## SIDDIQUI ORTHODONTICS JSP17-80

Consideration at the request of Siddiqui Orthodontics for Preliminary Site Plan and Storm Water Management plan approval. The subject property contains 1.33 acres and is located in Section 17, on the east side of Wixom Road and south of Grand River Avenue, in the Novi Promenade Shopping Center. The shopping center is subject to a Consent Judgement which directs the B-3 General Business standards be used to evaluate development of the outlots. The applicant is proposing to construct a single story 2,696 square foot addition to the rear of the former Huntington Bank building on Wixom Road near Target.

# PLAN REVIEW CENTER REPORT

Preliminary-Final Site Plan

**SHEET TITLE:**  
 TOPOGRAPHICAL SURVEY  
**PROJECT TITLE:**  
 27250 WIXOM ROAD  
 PART OF THE NW 1/4, SEC. 17, T.1N., R.8E.  
 CITY OF NOW, OAKLAND COUNTY, MI

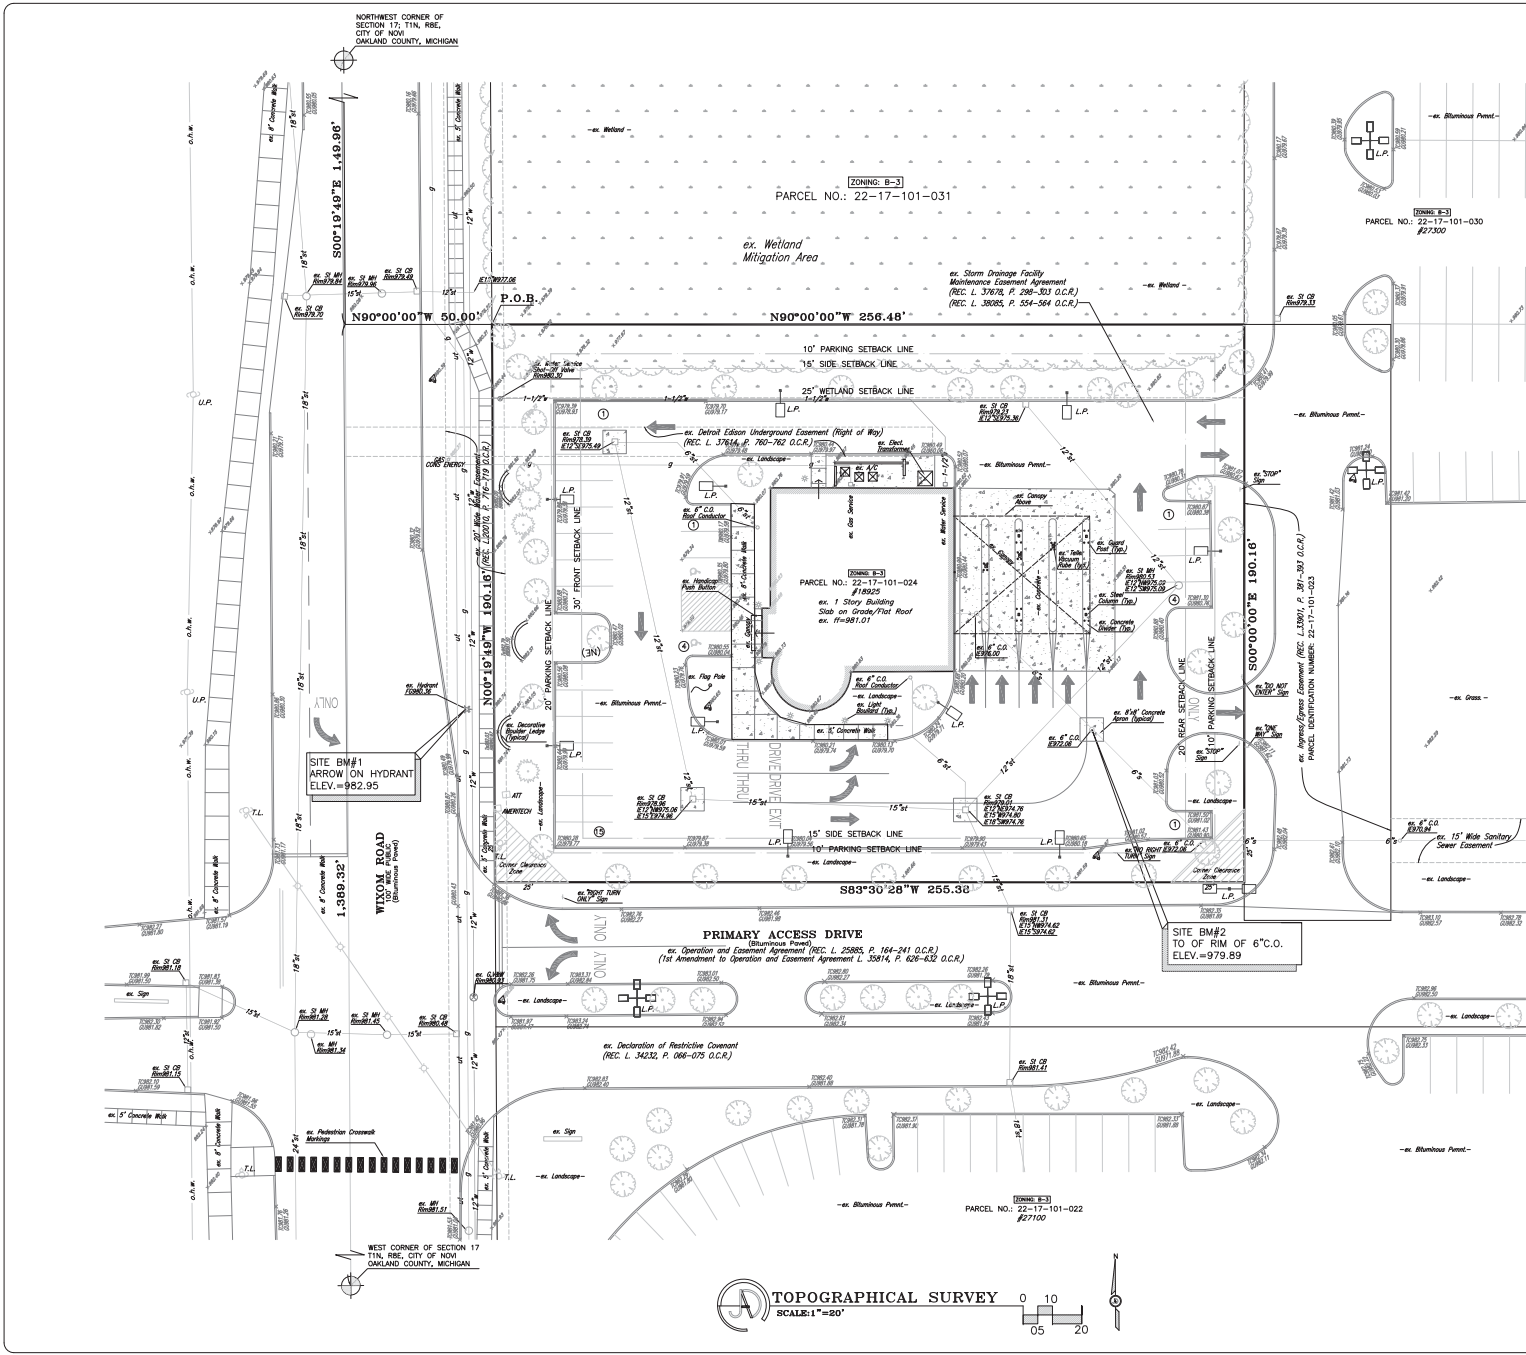
3. The benchmark description and information is not legible on sheets C1, C3 and C4 due to overlapping text. Please revise.
4. If no new signs are proposed, remove the HC sign detail from sheet C2. If signs are to be provided as called out, include a traffic control sign table listing the quantities of each sign type proposed for the development. Provide a note along with the table stating all traffic signage will comply with the current MMUTCD standards.

**SHEET TITLE:**  
 SITE PLAN  
**PROJECT TITLE:**  
 27250 WIXOM ROAD  
 PART OF THE NW 1/4, SEC. 17, T.1N., R.8E.  
 CITY OF NOVI, OAKLAND COUNTY, MI

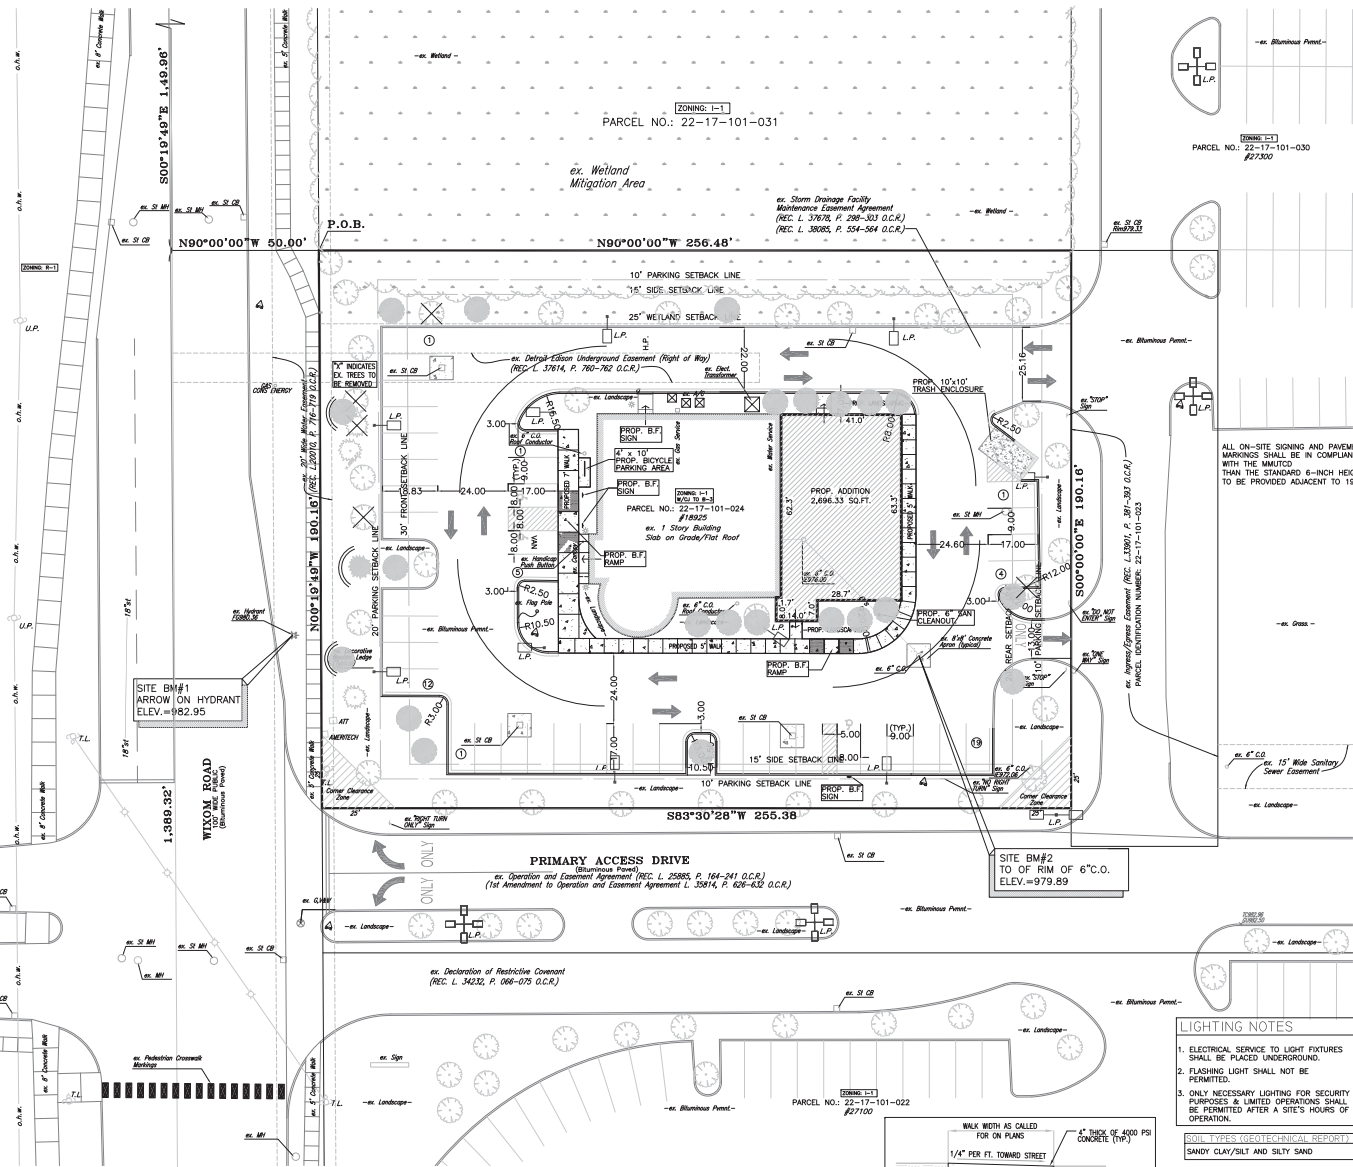
4. Proposed Trees: On Sheets C-2, C-3, and C-4 many trees are shown in solid grey and block important text and details of the plans. **Please remove these or change the symbol to be transparent as it makes it difficult to read the plans. Proposed landscaping details may be shown on the Landscape Plan only.**

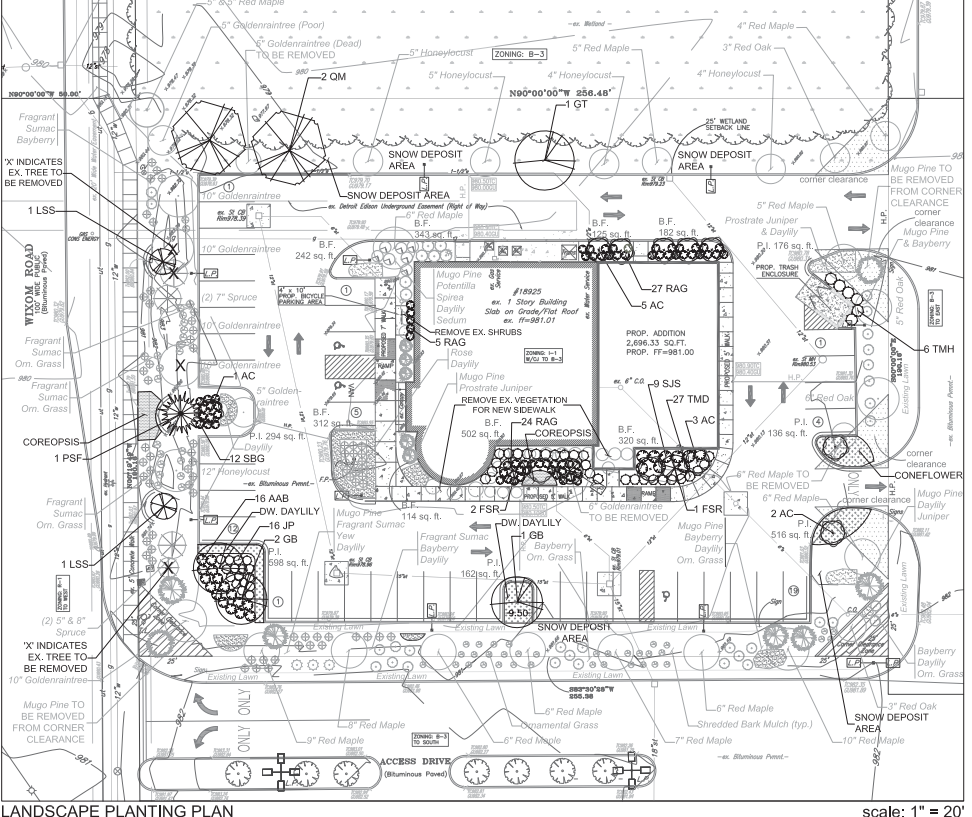
1. The existing berm is 1-2 feet shorter than required so **a landscape waiver is required.**
2. This waiver is supported by staff because all existing vegetation would have to be removed to increase its height.
3. The existing trees and shrubs exceed the current greenbelt planting requirements, even with the removals of 3 trees.

1. Based on the vehicular use areas, 1,624 sf of islands and 8 trees are required. 2,140 sf of islands and 8 trees are provided.
2. **Please replace the 2 serviceberries with a deciduous canopy tree with a minimum mature height of 30 feet and mature canopy width of 20 feet. The serviceberries do not meet this requirement.**

1. Based on the building perimeter, less the paved access areas, 2400sf of foundation landscaping is required and 2140sf is provided.
2. **A landscape waiver is required for the deficiency of 260sf (10.8%).** This waiver is supported by staff because there is a significant increase in foundation planting over what exists with the current building configuration.

1. Provided.
2. **Please revise per the Parking Lot landscaping comment.**
